# cROP Significance Determination Process 6-10-10 DRAFT

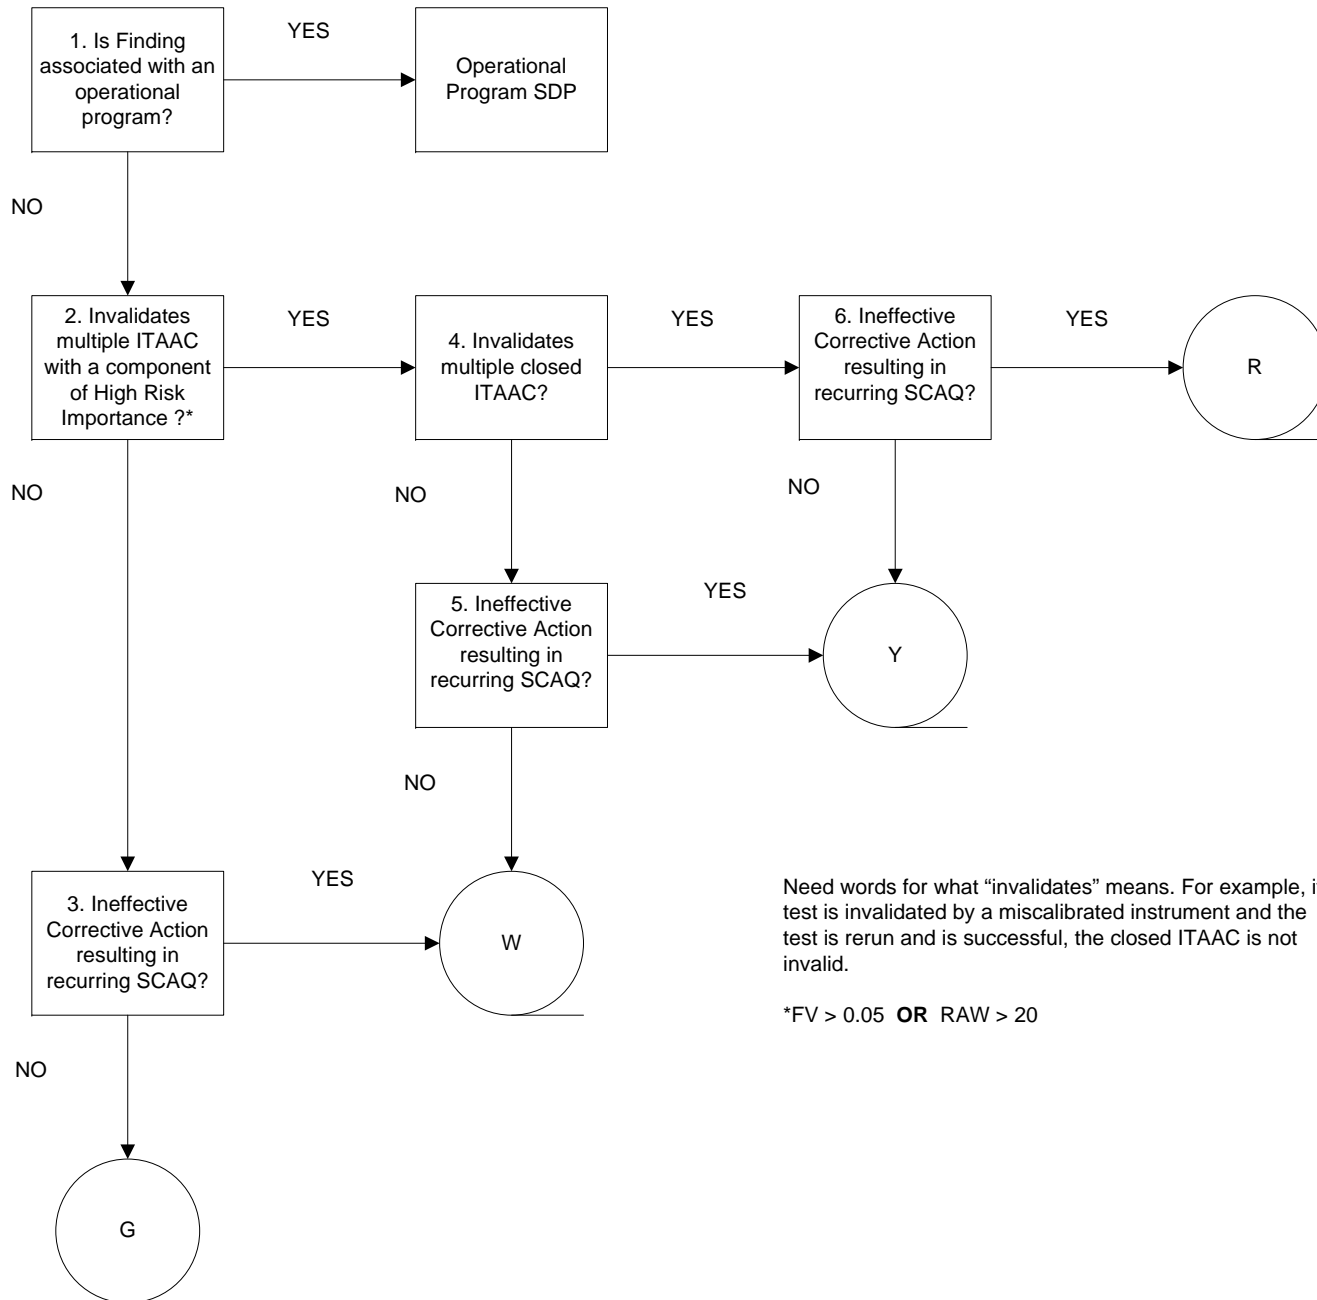
Need words for what “invalidates” means. For example, if a test is invalidated by a miscalibrated instrument and the test is rerun and is successful, the closed ITAAC is not invalid.
